APPLICATION NO.	FILING DATE	FIRST NAMED INVENTOR	ATTORNEY DOCKET NO.	CONFIRMATION NO.
10/090,885	03/04/2002	Dean R. Brown	PWP0002/US/2	6454

<p align="center">Office Action Summary</p>	<p>Application No.</p> <p>10/090,885</p>	<p>Applicant(s)</p> <p>BROWN, DEAN R.</p>	
	<p>Examiner</p> <p>David T. Fidei</p>	<p>Art Unit</p> <p>3728</p>

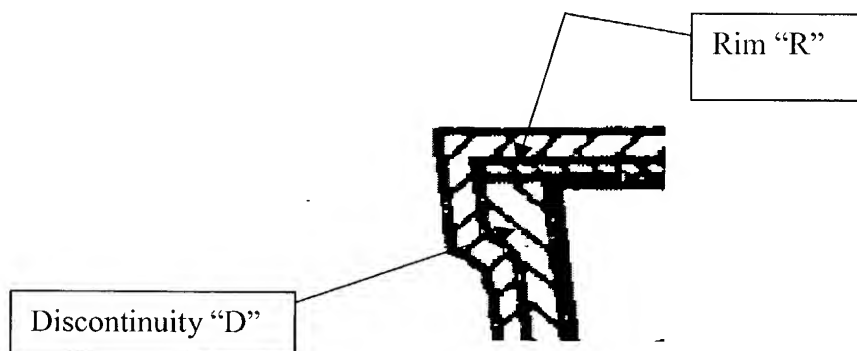
2. Claims 1, 2, 6 and 7 are rejected under 35 U.S.C. 102(b) as being anticipated by Ando (Patent no. 3,976,795). As to claim 1 (amended), Ando discloses a container (1) for storing items, comprising: a container bottom; a side wall extending upward from said bottom and terminating in a rim (R, shown below defined as that planar surface where the lid attaches to the container) defining the periphery of said container, said side wall tapering from top to bottom; a lid (5) covering said container; a surface discontinuity (D, shown below) disposed on said side wall intermediate said rim and said container bottom: and a layer of shrinkwrap (7).

The shrinkwrap film of Ando is described as heat contracted to such a degree that it adheres airtight to the container 1, see col. 3, lines 6-8. Hence, the layer of shrinkwrap is formed to and clings to at least a portion of said tapered side wall, wherein said layer of shrinkwrap is formed to and covers said surface discontinuity and conforms to the shape thereof.

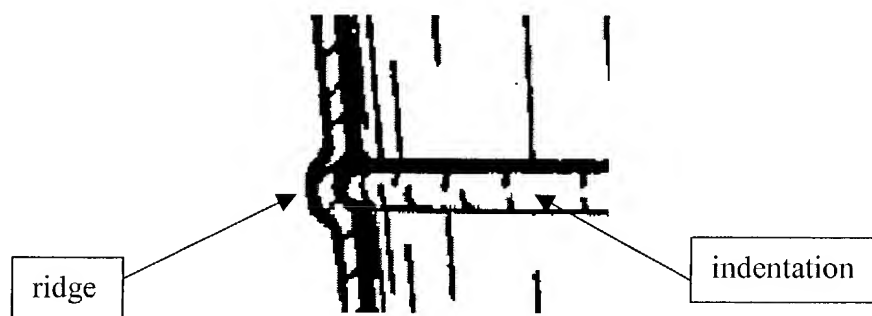
Karevaara is cited for the teachings of figures 1-7. In figure 2, an indentation is defined on the inside surface of annular projections 5, 6 that also forms a ridge extending continuously around the container side wall (as per claims 8 & 9). Note representation below.

As to claim 10, a plurality of indentations can be said to be disclosed by Karevaara in that there are two indentations formed on the inside surface of the container side wall at each location of projections 5 & 6. Hence, Karevaara teaches the subject matter of claims 8-10.
